UNITED STATES PATENT AND TRADEMARK OFFICE

APPLICATION NO.	FILING DATE	FIRST NAMED INVENTOR	ATTORNEY DOCKET NO.	CONFIRMATION NO.
10/810,297	03/26/2004	Luigi Tallone	36030312 US02	9276

Office Action Summary

DETAILED ACTION

FIG. 3I

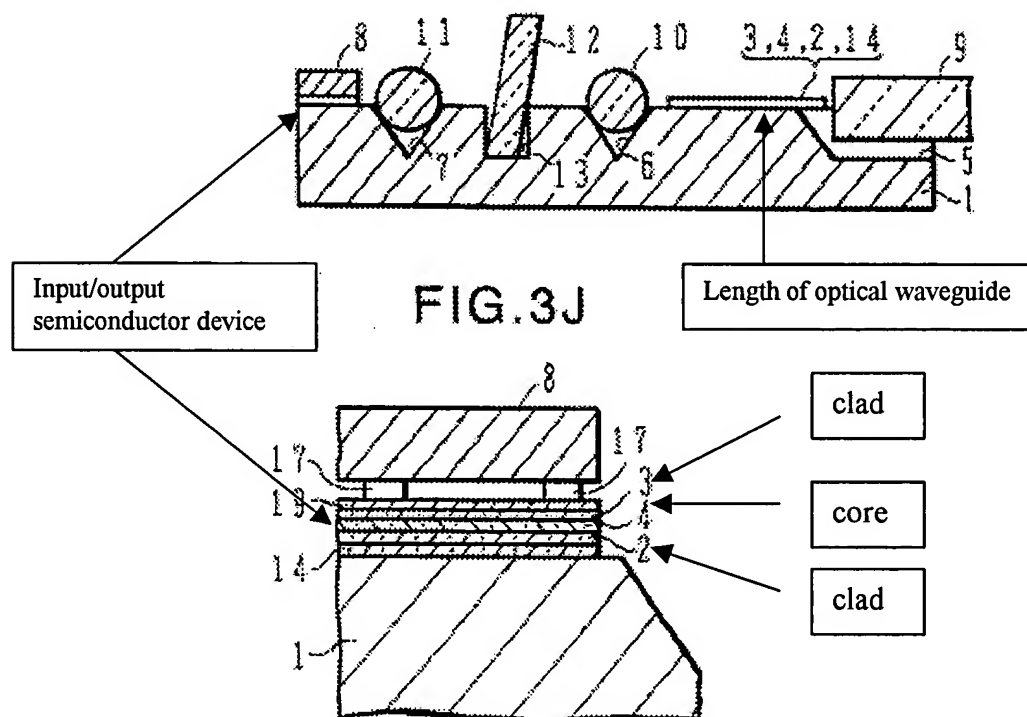
Regarding claims 1 and 15, Tabuchi discloses a mounting arrangement comprising a substrate (1), referring to Fig. 2A, 2B, and 6, an input optical fiber (9) associated with said substrate an output optical waveguide (‘2’ ‘3’ ‘4’) in a given set of planar layers of said output waveguide wherein the output waveguide and the further optical waveguide are aligned along an input-to-output propagation path, thereby providing substantial alignment of said output optical waveguide and said further optical waveguide, said further optical waveguide is interposed between said input optical fiber and said optical component (ball lens 11, isolator 12, or ball lens 10) and wherein said optical component is interposed between said further optical waveguide. Furthermore, Tabuchi teaches an input/output optical semiconductor device (8) further comprising a waveguide (‘2’ ‘3’ ‘4’). Since the core and the claddings of the two segments of waveguides are referred to with the same numeric reference, for differentiating purposes the output waveguide will be referred to as (8) and the length of optical waveguide will be referred to as (14). The length of optical waveguide (14) on said substrate in the same planar layers of

said output optical waveguide (8), the length of optical waveguide is interposed between the input optical fiber (9) and at least one optical component (10, 12, 11) so that at least one optical component is interposed between the length of optical waveguide and the output optical waveguide.

Claims 2, 7, and 16 substrate (1) is a silicon optical bench support; wherein the output optical waveguide and the length of optical waveguide are aligned along an input-to-output propagation path.

Claims 9-11, and 21-23, referring to Fig. 3J and see col. 8, lines 20-22 wherein Tabuchi discloses the optical member (12) may form an optical isolator by applying a thin laminated layer upon the substrate of the rectangular optical member (12). The examiner would like to point out that an optical isolator is a one-way filter for a range of light frequencies. Regarding claim 22, this is a functional limitation within a device claim, thus the limitation retains no patentable weight.

FIG. 2A

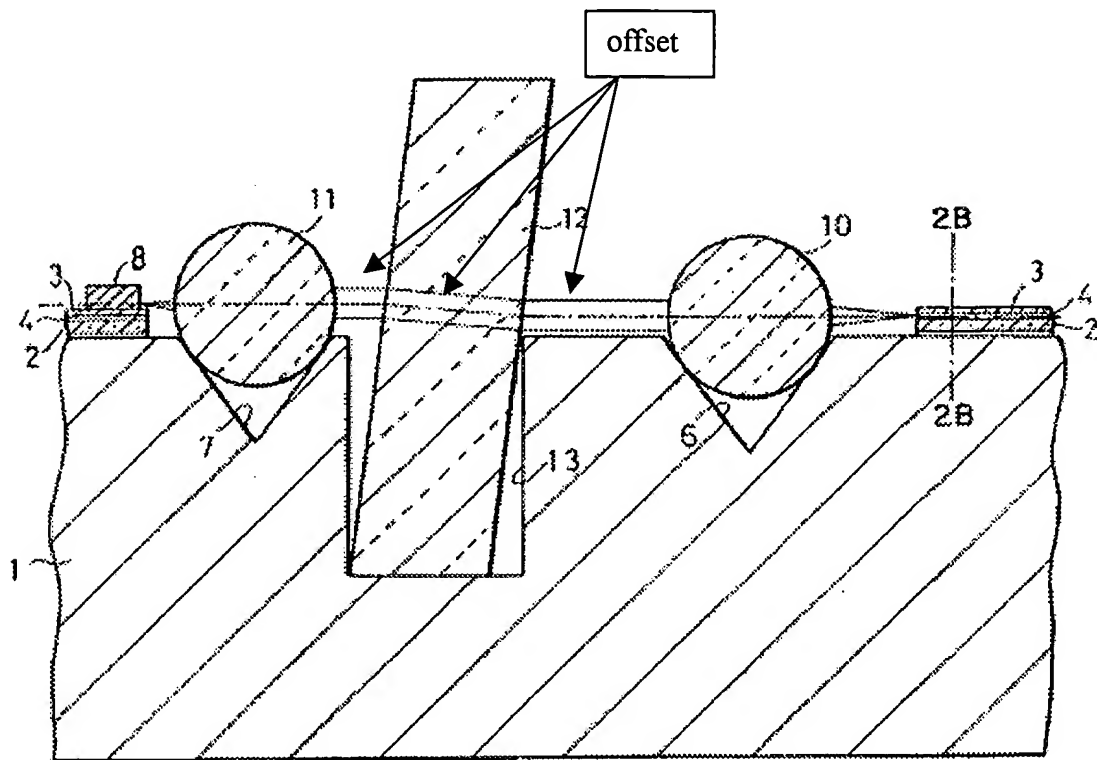
Regarding claim 8 wherein the end surfaces of the output waveguide and the length of optical waveguide are offset to a perpendicular to input-to-output propagation path and a

propagation path of radiation through at least one optical component is at an angle with respect to the input-to-output propagation path.
